**Re: Jackson Hydroelectric Project, FERC No. 2157
License Article 415 Water Temperature Conditioning Plan Amendment for Phase 2
Structure Design Change**

ATTACHMENT 1

Modifications to Sections 2.2, 2.3, and 3 of WTC Plan

Figure 2. Plan sketch for Phase 2 concept.

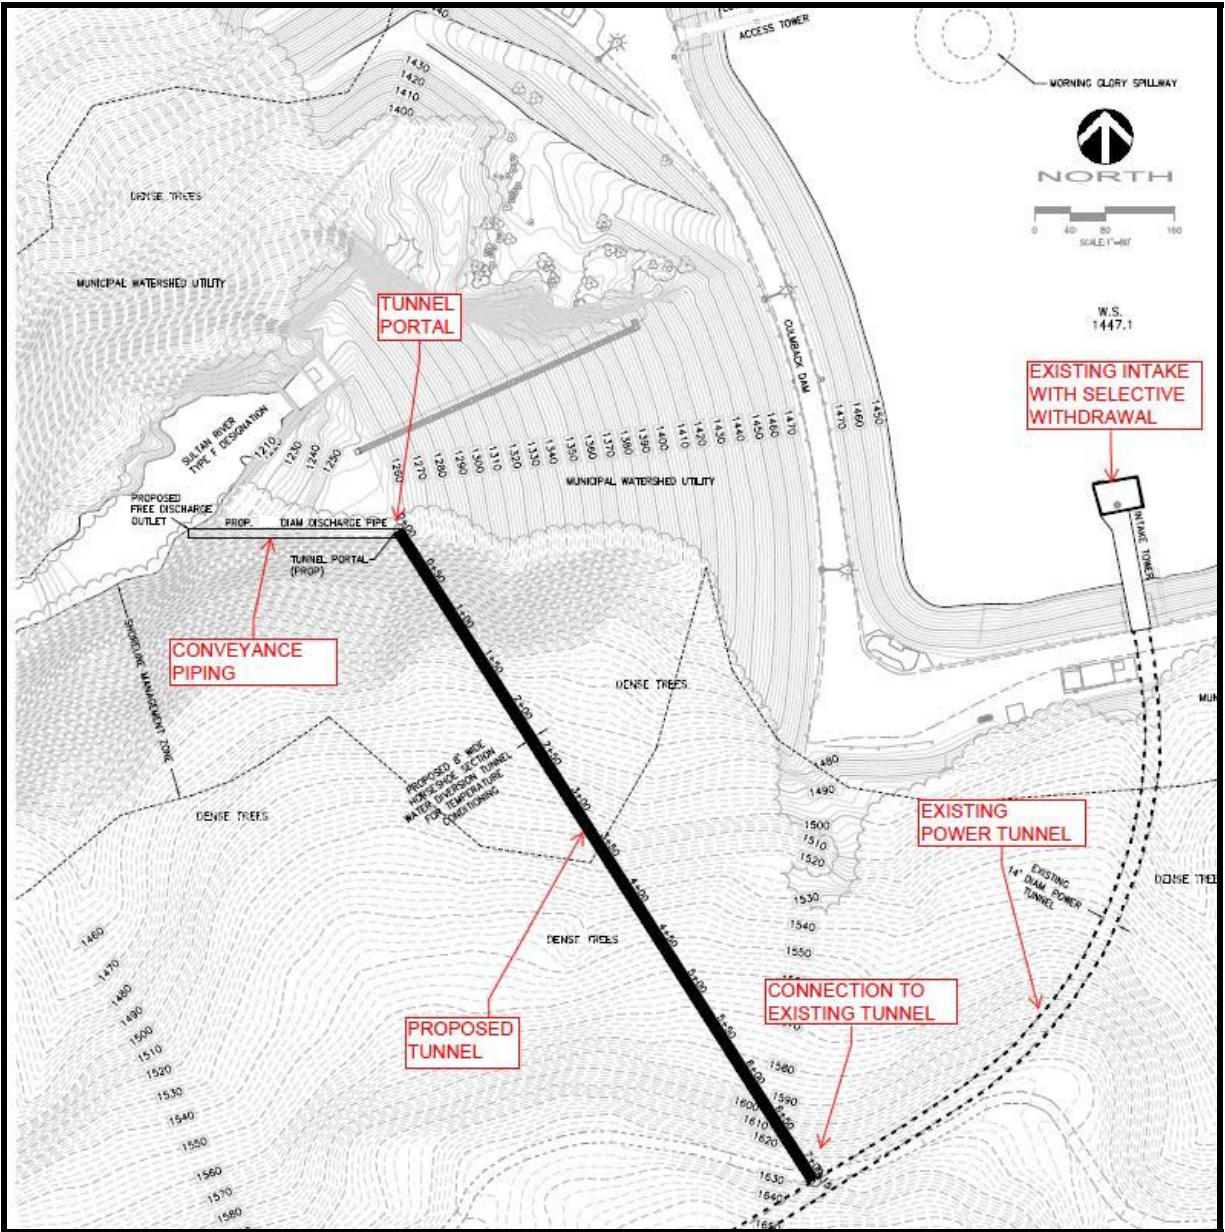
The Phase 2 WTC project would utilize the existing Intake Structure and Power Tunnel, together with a proposed WTC Tunnel to deliver conditioned water to the head of Reach 3 of the Sultan River at the base of Culmback Dam (see Figure 2). If necessary, supplemental water could be provided via the Outlet Works and existing Auxiliary Release Line for additional temperature conditioning.

Figure 3. Typical panel configurations at existing intake structure.

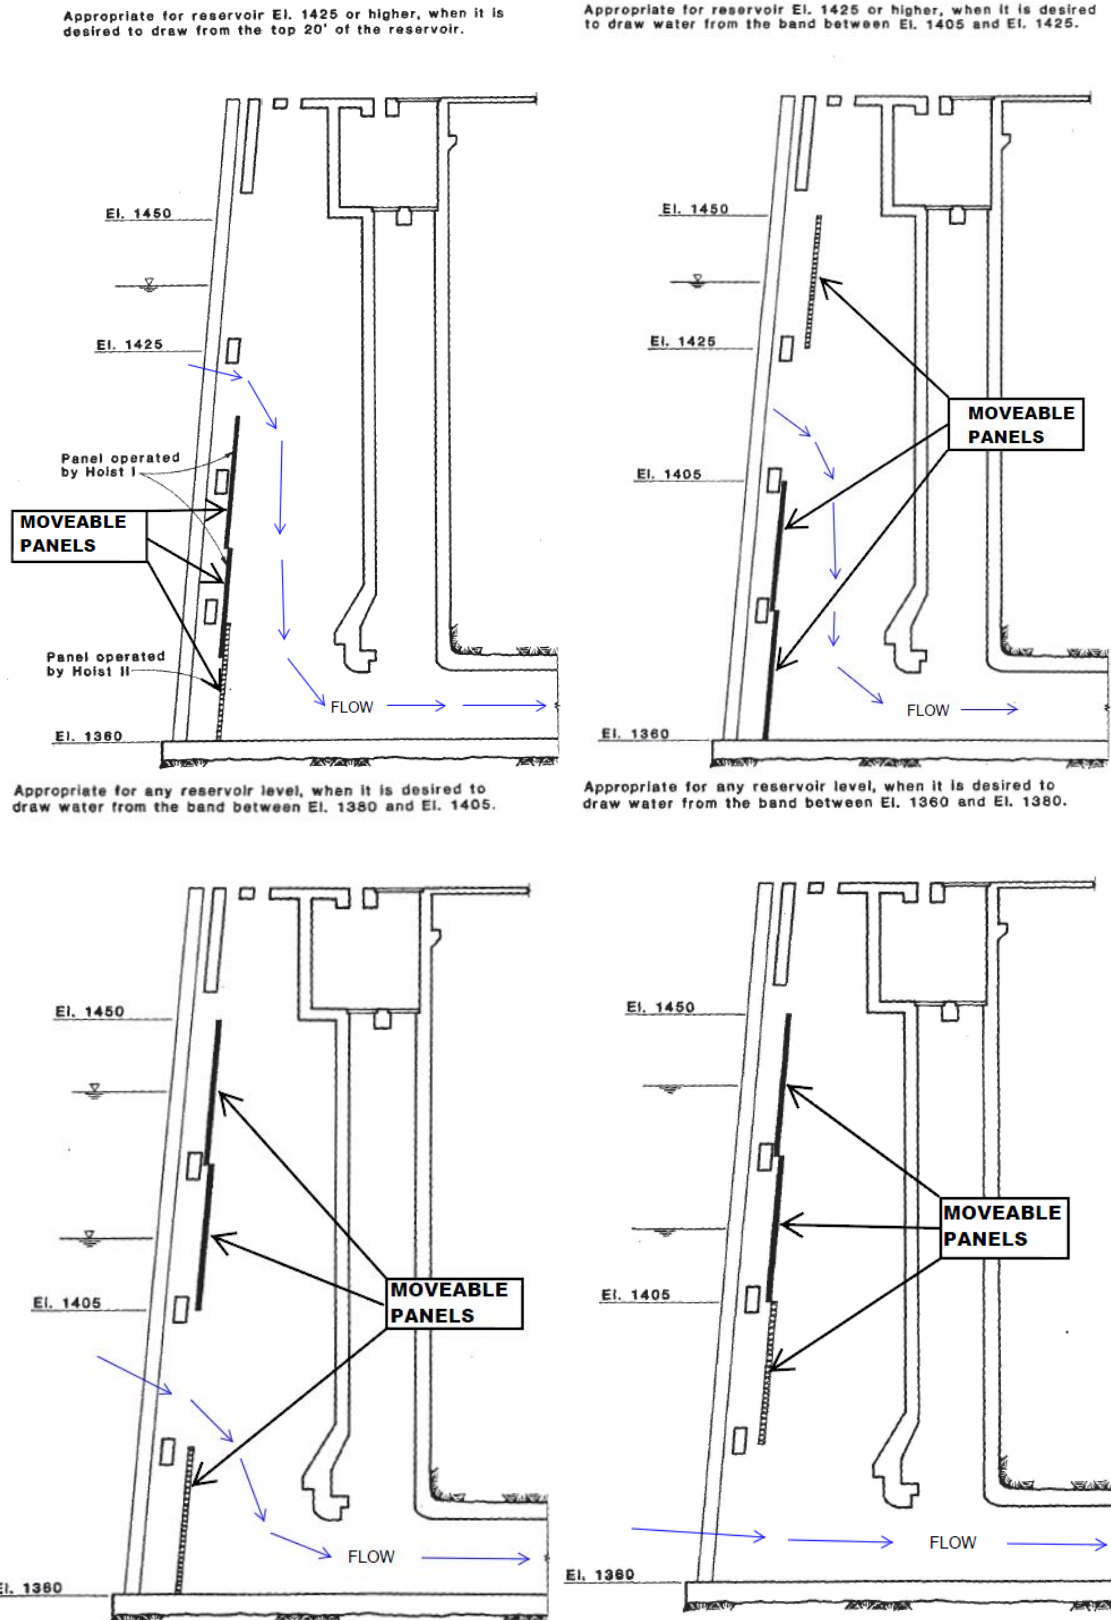
The project would utilize the existing Intake Structure located near the left abutment of Culmback Dam, and its selective water withdrawal capability (see Figure 3). The structure includes a trashrack and three moveable panels operated by wire rope hoists. The upper panels consist of two individual bulkheads and the lower panel is a single bulkhead. The panels can be positioned in five primary configurations to selectively withdraw water of different temperature from the reservoir. A headgate allows isolation of the Power Tunnel downstream. The Power Tunnel is a 14-foot diameter un-lined tunnel in hard rock.

Figure 4. Tunnel sections.

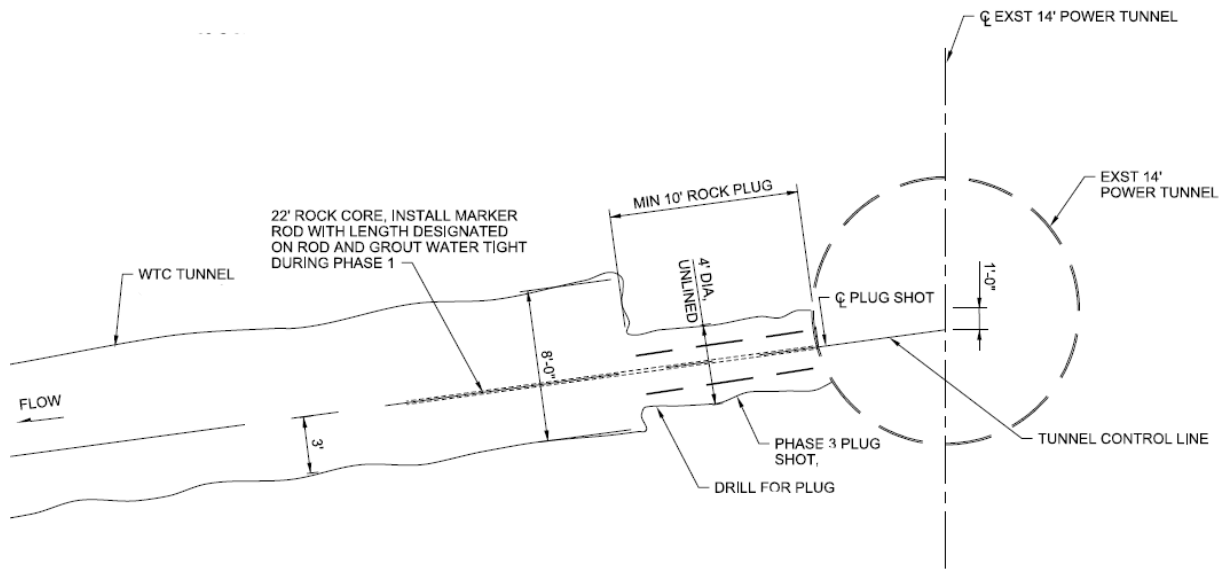
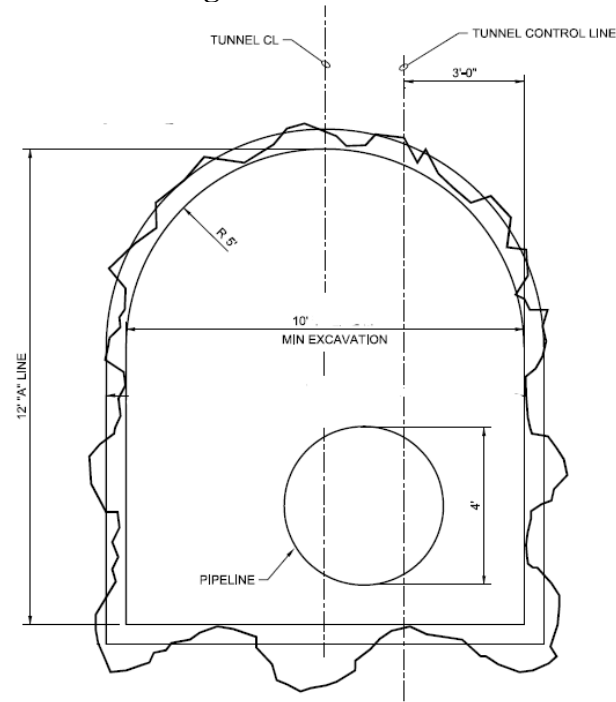
The new design concept is to divert water from the existing Power Tunnel into the most upstream section of Reach 3, at the base of Culmback Dam, via a proposed diversion tunnel. The proposed tunnel would range from 72 inches to 120 inches in diameter (depending on the type of construction) and be roughly 750 feet long. This design relies on the selective withdrawal capabilities of the existing Intake Structure in Spada Lake Reservoir.
